Technical Memorandum: Darrow Road Park Basin Hydrologic & Hydraulic Study

Darrow Road Park Basin Study
Hudson, Ohio

Comment Responses

Figure 2: Proposed PCSWMM Schematic (**Storage Alternative 1**)

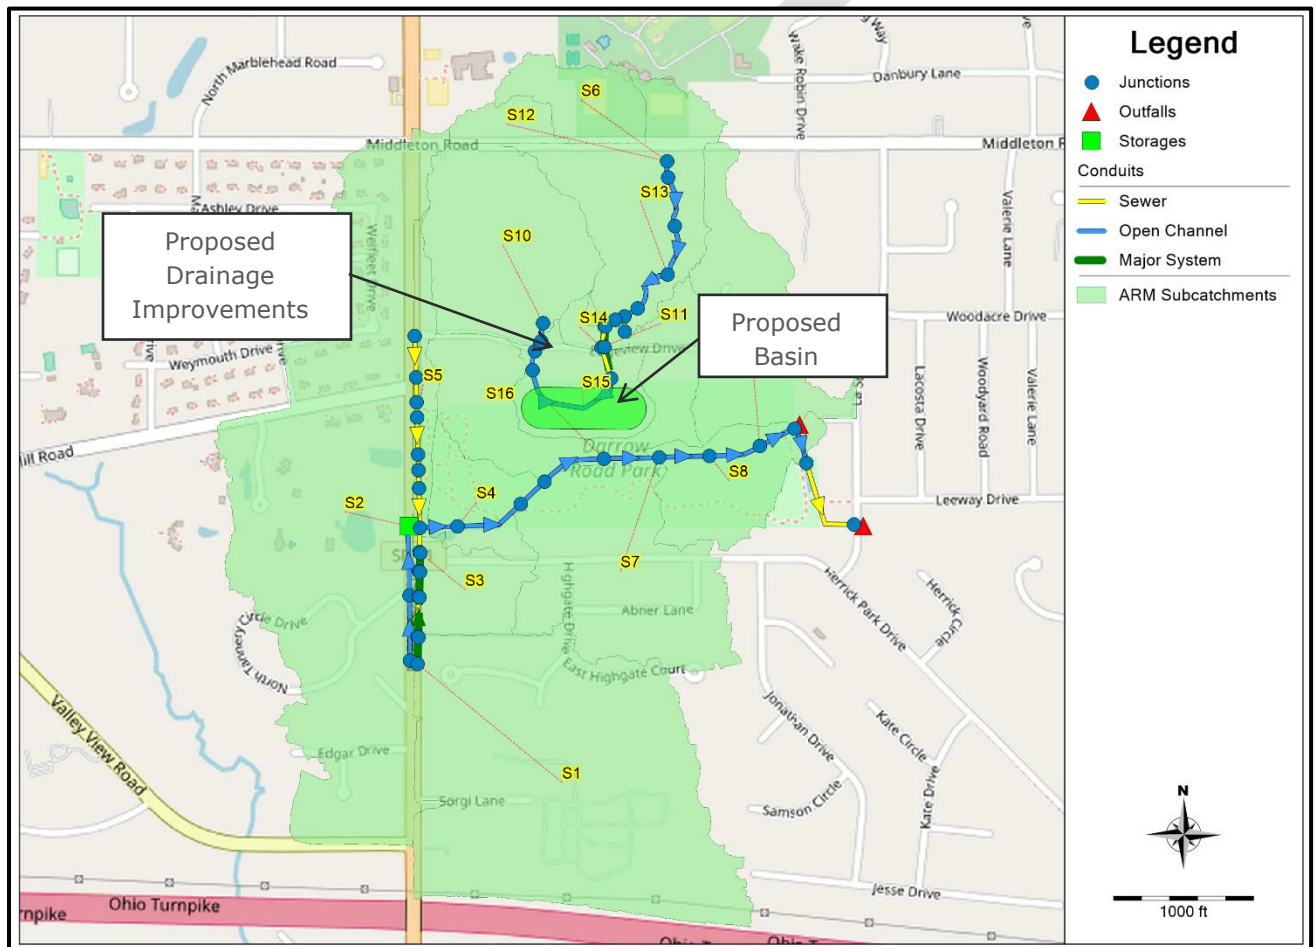
City comment: Would two smaller basins at each channel location be "better"?

GPD response: Two basins could function as well as one basin. Some things to consider would be environmental permitting and long-term maintenance. It may be easier to permit and maintain a single basin versus two.

Basin Schematic

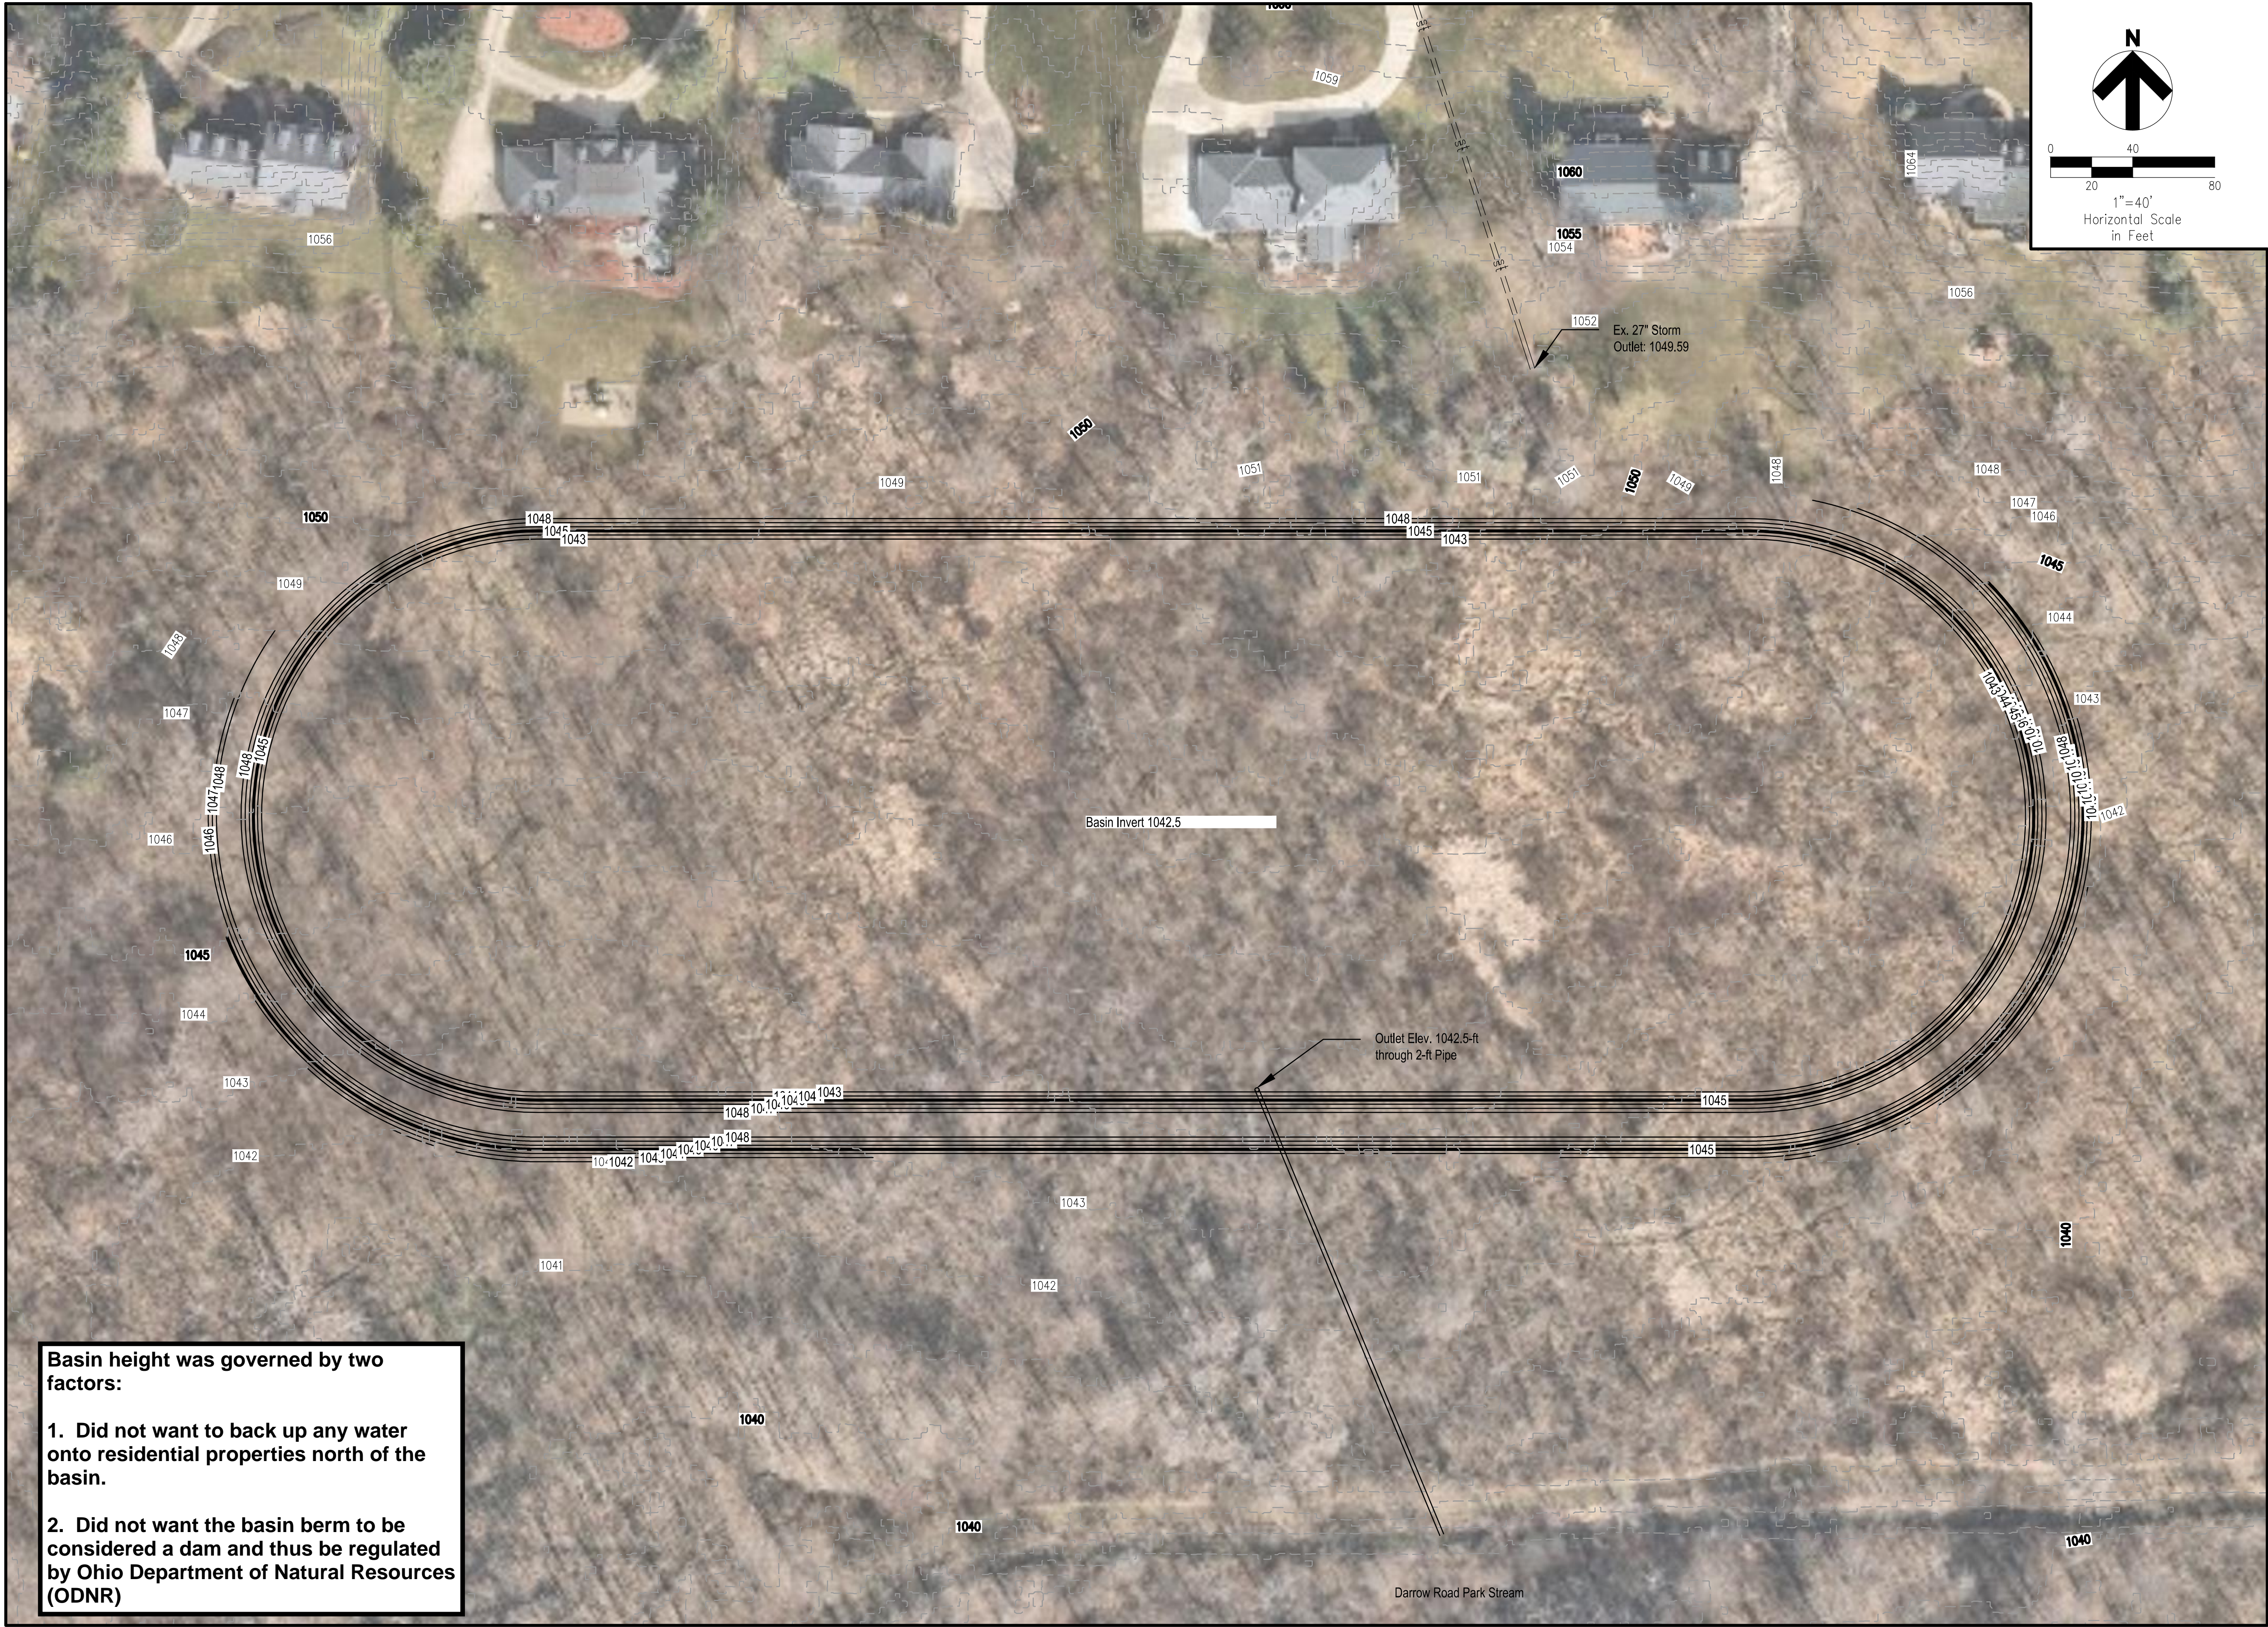
City comment: Why isn't more pond volume being utilized in the scenario presented.

Basin height was governed by two factors:

1. Did not want to back up any water onto residential properties north of the basin.
2. Did not want the basin berm to be considered a dam and thus be regulated by Ohio Department of Natural Resources (ODNR)

GPD response: The basin size and footprint were somewhat arbitrary. We had a set height we were targeting to not back up water onto the properties to the north and to keep it out of being regulated by ODNR. We made a large basin to be sure that we had enough storage, knowing that if the project was pursued, it could be right sized based on the volume needed.
